STANDARD DREDGE AND FILL WETLANDSPERMIT APPLICATION

Description: Widening Shirkin Road which in this section is a class 6 road.

RE: Shirkin Road widening Fremont NHB21-2707

Shirkin Road Fremont D & F application. Approximate locations of the wetland impacts are shown as red lines along the road. Red arrows indicate approx. culvert locations 12" (new) 18

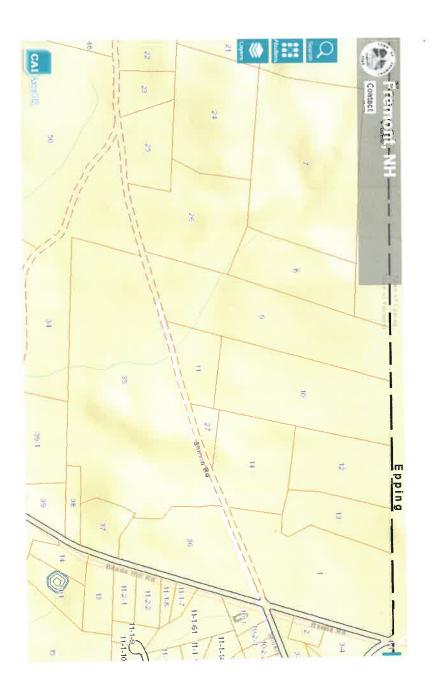
Please provide a simple Google Earth aerial showing locations of all proposed culvert replacements.

We have revised the road widening plan in accordance with your suggestions. The changes include increasing the size of the two existing 12" plastic culverts to 18" RCP, specifying rounded "river rocks" for the outlets of the culverts (low flow), no exposed geotextile. An Alteration Of Terrain permit will not be required for this project. I have not observed any Beaver activity in these wetlands. The road will not be paved under this permit. The road improvement will be about 2,040 feet in length and the average increase in height of the road will be approximately one foot. This project extends the approved widening of another section of Shirkin Road with similar wetland impacts east to the junction with Beede Hill Road. ECC-2B erosion control blankets are specified. I have attached a copy of the revised plan and the Google Earth graphic showing approximate locations of wetland impacts and culverts.

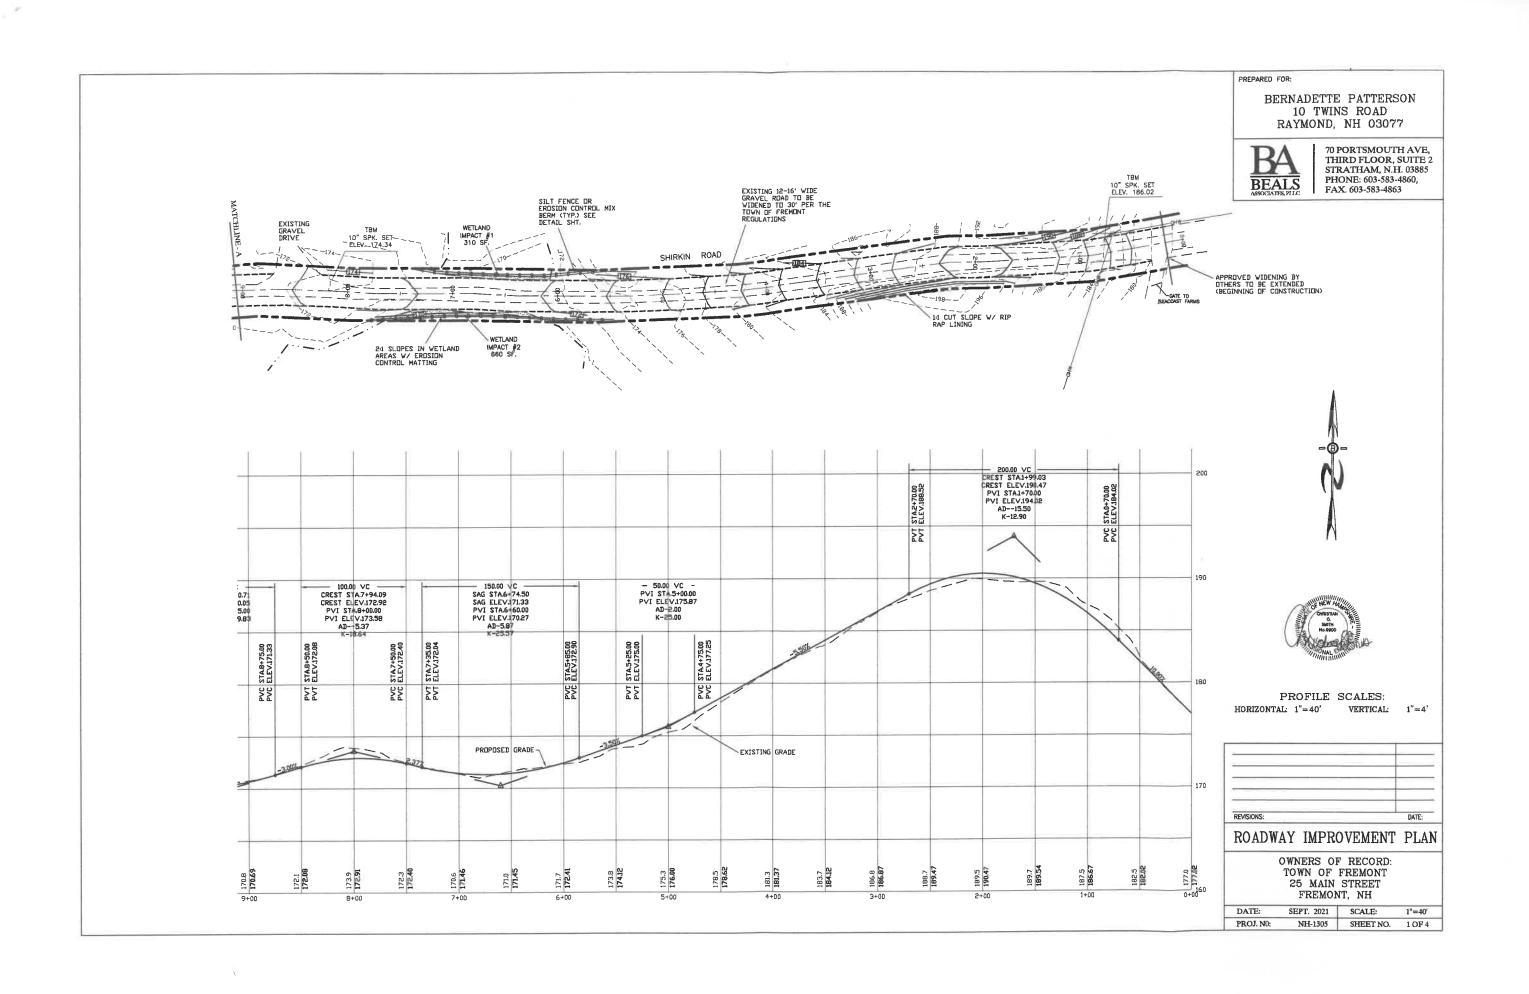
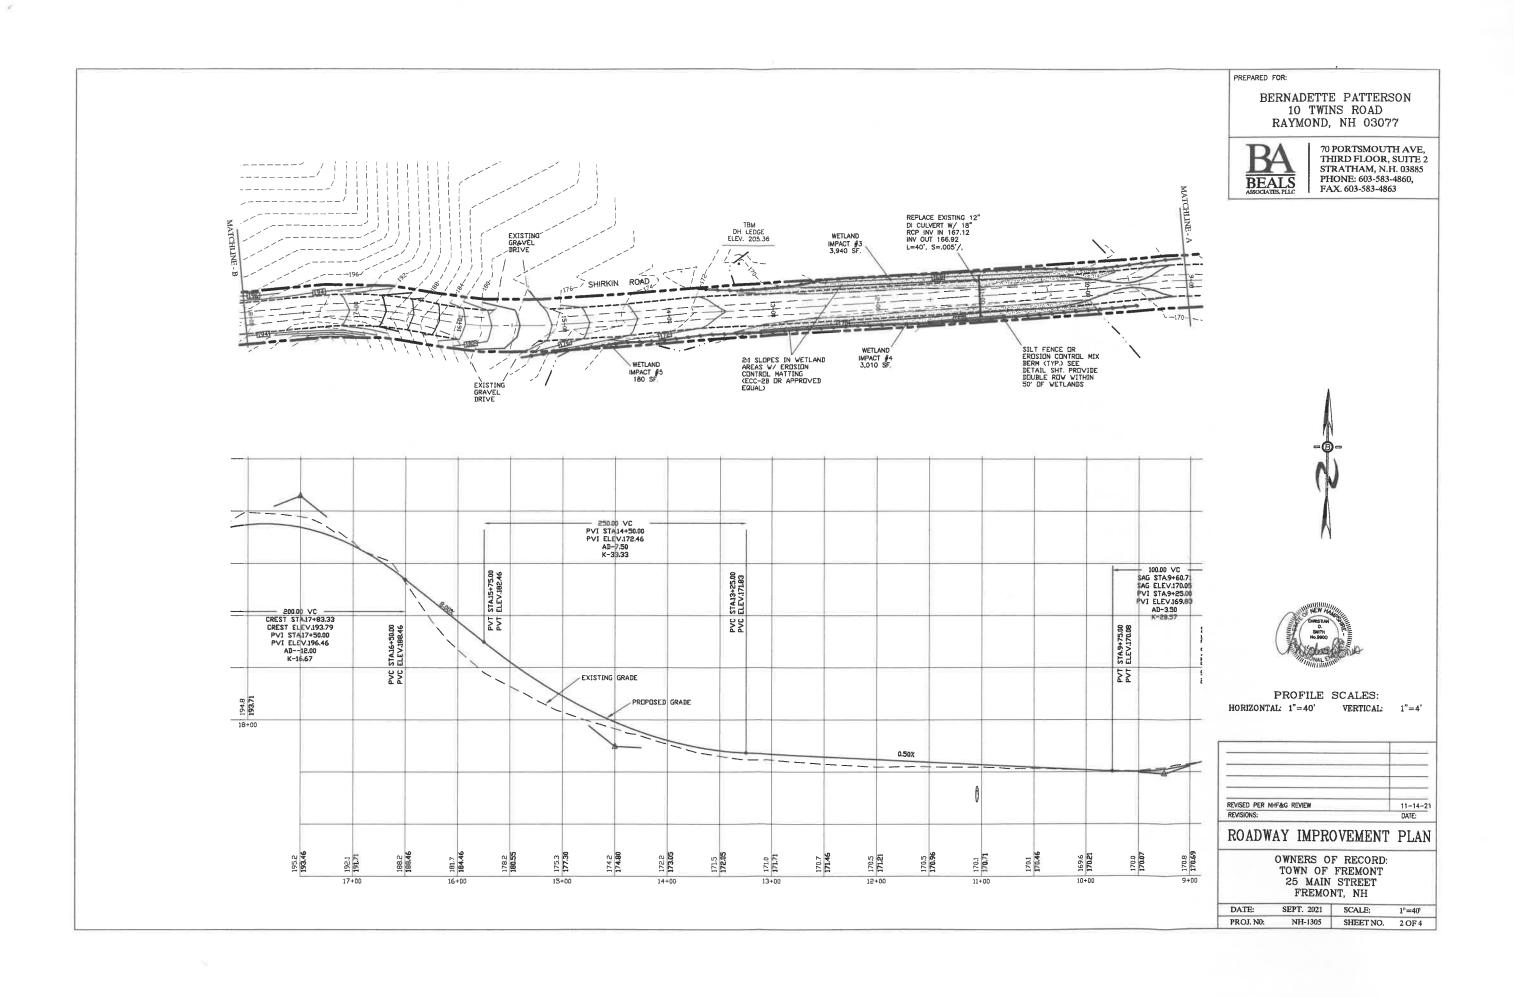
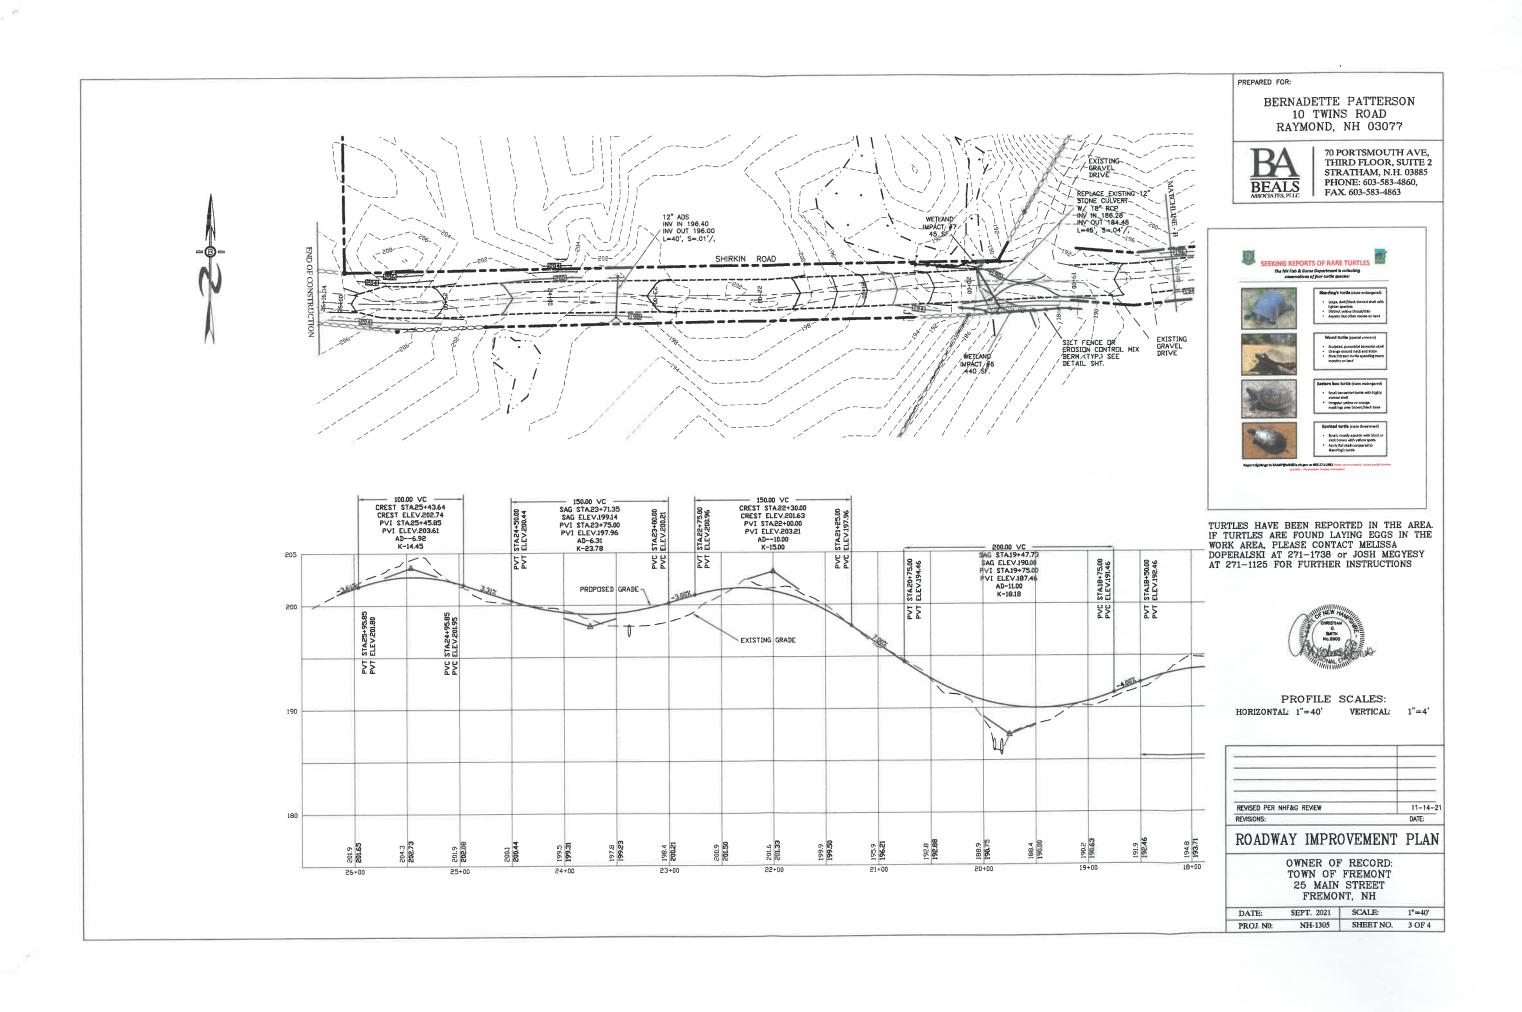
Impact Areas #2 and #5 look like they could use a much larger RCP or CMP culvert than a 12". Also consider ellipticals. Impact #5 looks like it is plugged by beavers- please confirm. How many of the culverts have this problem? Please send photos of inlets and outlets of all proposed replacements and consider upsizing at all locations as this is a high priority area for Blanding's and other listed turtles. Are there any other DES permits associated with this job like an AoT? We will only consider plastic culverts at wetland crossings with little or no current and that are backwatered at all times. Please send a job narrative describing the entire project. Will the road be paved? Please include NHB file number in the subject line of all emails pertaining to this job. There looks like there was a diagram for a box culvert in the plan- what size is it and where is it going? If there is little flow at these crossings, rip- rap should not be required at inlets and outlets- replace with natural smooth stone if needed. Avoid using geotextile fabric in wetlands.
